**DEFICIENCIES IN DOE STANDARD 5506-2007,
*Preparation of Safety Basis Documents for Transuranic
(TRU) Waste Facilities***

**Defense Nuclear Facilities Safety Board
Technical Report**

February 2018

Figure 1. Results of Monte-Carlo statistical sampling test of the MAR algorithm for the case of a uniform MAR distribution, using inventory sizes of $N = 100$ and $N = 1000$.

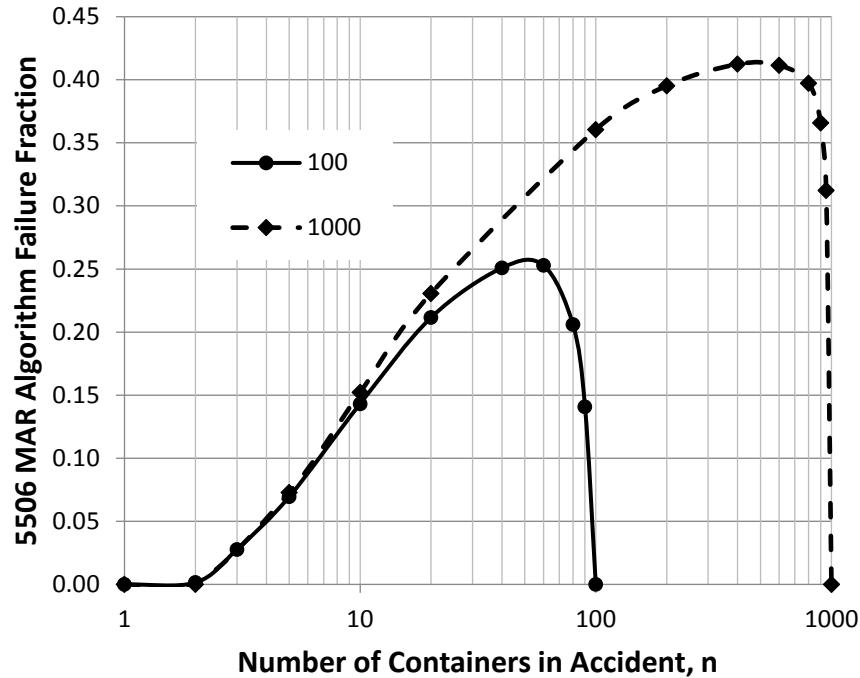
Figure 1 shows the results of the staff’s statistical test for the case of a uniform distribution of MAR within an inventory of waste containers. The staff considered two inventory sizes, $N = 100$ and $N = 1000$. The staff performed approximately 20,000 Monte-Carlo sampling trials to obtain each data point shown. The horizontal axis in Figure 1 shows the number of containers involved in the accident, n . The vertical axis shows the failure fraction of the statistical MAR algorithm. Figure 1 shows that the algorithm does not bound the sampled MAR anywhere in the range $1 < n < N$. Any time the failure fraction (fraction of cases where the algorithm does not bound the actual sample) is greater than zero, it means the algorithm does not bound the actual sample for a percentage of tests in the Monte-Carlo statistical sampling tests. The failure fraction exceeds 15 percent for a sample size of 11 to 89 drums out of a given inventory of 100 containers. The failure fraction exceeds 40 percent for a sample size of approximately 200 to 800 drums out of a given inventory of 1000 containers. The Board’s staff also evaluated other distributions of MAR inventories, including Gaussian, lognormal, and skewed, and obtained similar results.

- The Board's staff determined that the statistical MAR methodology outlined in DOE Standard 5506-2007 is not bounding, and is therefore not consistent with DOE Standard 3009-2014, which requires a bounding MAR to be used in hazard and accident analysis. Statistical tests performed by the Board's staff suggest that the statistical MAR methodology may have a high fraction of cases where it fails to bound actual MAR values.

Figure 2. Variation of the mean MAR among rooms at WIPP.

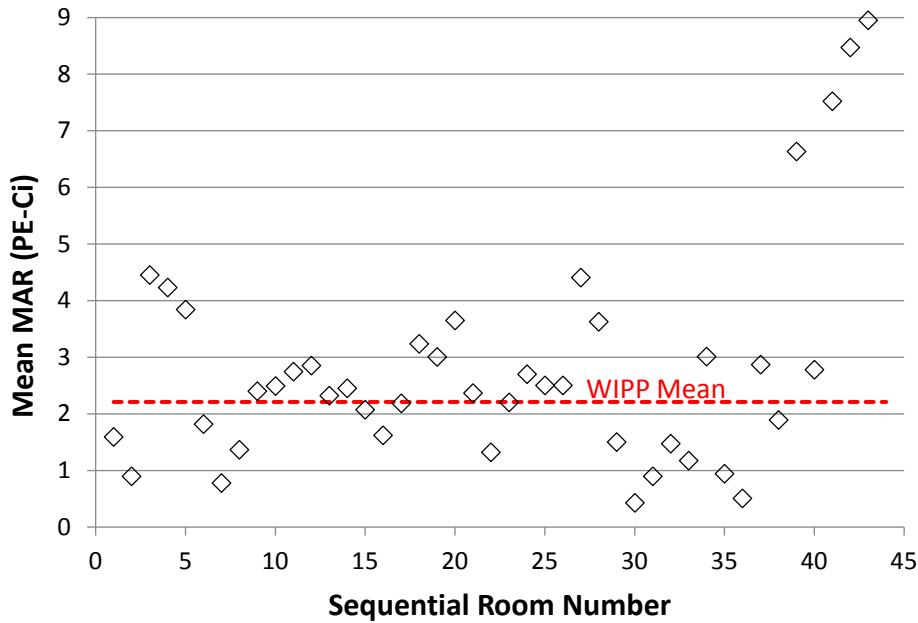
Evaluation of WIPP Inventory—The Board’s staff evaluated how the quantity of MAR in emplaced 55-gallon drums varies within the underground at WIPP. The staff calculated the mean MAR in 55-gallon drums for each of the 43 rooms in the WIPP underground. Figure 2 shows the calculated mean MAR in 55-gallon drums by room number. The dashed line shown in Figure 2 is the mean MAR for all 55-gallon drums at WIPP, 2.21 plutonium equivalent curies (PE-Ci). WIPP uses the mean MAR for all 55-gallon drums underground at WIPP when applying the statistical MAR methodology. However, Figure 2 shows that the mean MAR per room varies considerably in the WIPP underground. The Board’s staff concluded the variability in MAR per room is not random statistical variation, since the rooms contain a large number of drums (approximately 2,000 per room on average). The results shown in Figure 2 suggest that bias associated with individual waste transfer campaigns from different sources contributed to the variation. The staff’s conclusion calls into question the conservatism of the statistical MAR methodology, which relies on the global mean MAR to compute the MAR involved in a localized accident.

- The staff's analysis of MAR in the WIPP underground demonstrates that relying on global waste inventory for formulation of key inputs to the statistical MAR algorithm in DOE Standard 5506-2007 may not be appropriate.

Figure 3. DOE Standard 5506-2007 interpretation of aircraft and vehicle crash assumptions.

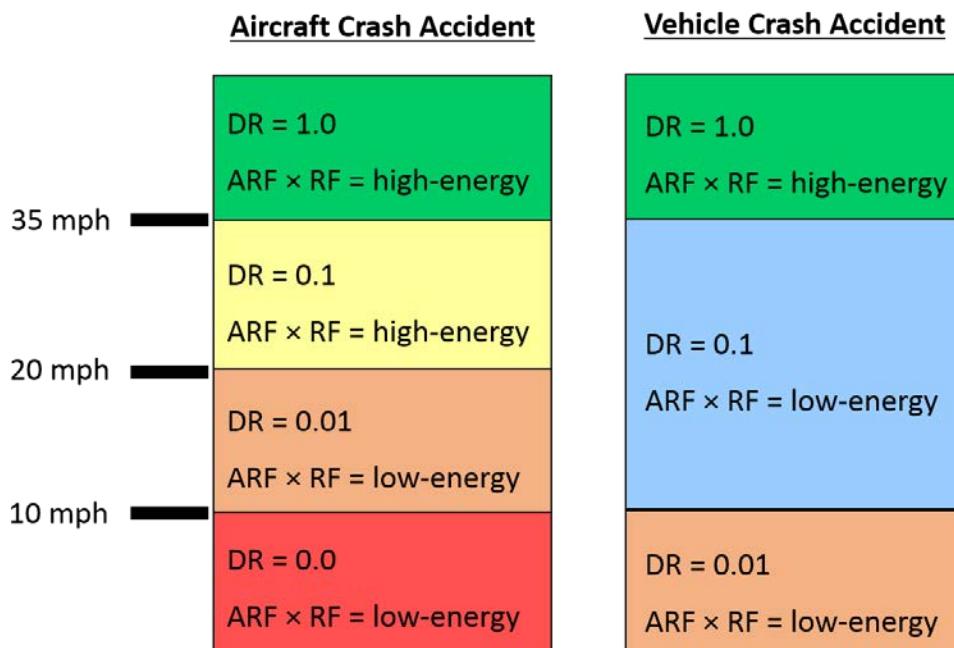
The guidance in DOE Standard 5506-2007 for estimating a radioactive material release due to a vehicle crash or aircraft crash into TRU waste containers does not provide sufficient detail to ensure consistent and conservative application across all TRU waste facilities. Furthermore, the lack of detail has contributed to inconsistent application of damage ratio and airborne release fraction times respirable fraction ($ARF \times RF$) values for vehicle and aircraft crashes. Figure 3 illustrates how aircraft and vehicle crash accidents have applied different combinations of damage ratio and $ARF \times RF$ as a function of impact velocity, based on interpretation of guidance provided in DOE Standard 5506-2007.

Low-Energy vs High-Energy vs Catastrophic Impacts—The $ARF \times RF$ values cited in DOE Standard 5506-2007 can differ by an order of magnitude, based on whether they are classified as low-energy or high-energy impacts. DOE Standard 5506-2007 states that the high-energy impact $ARF \times RF$ values are applicable to a container fall from the fifth tier of stacked drums. This equates to a fall height of approximately 13.7 feet. A 13.7-foot fall height results in an impact velocity of approximately 20 miles per hour. A commonly used method in the aircraft crash accident analysis is to use the impact velocity calculated for a 13.7-foot fall height (i.e., 20 miles per hour) as the threshold above which high-energy impact $ARF \times RF$ values are applied.

DOE Standard 5506-2007 should clearly provide the thresholds that determine which damage ratio and ARF×RF should apply to both the aircraft and vehicle crash accidents, such that application is consistent for all relevant accident scenarios. Multiple variables must be
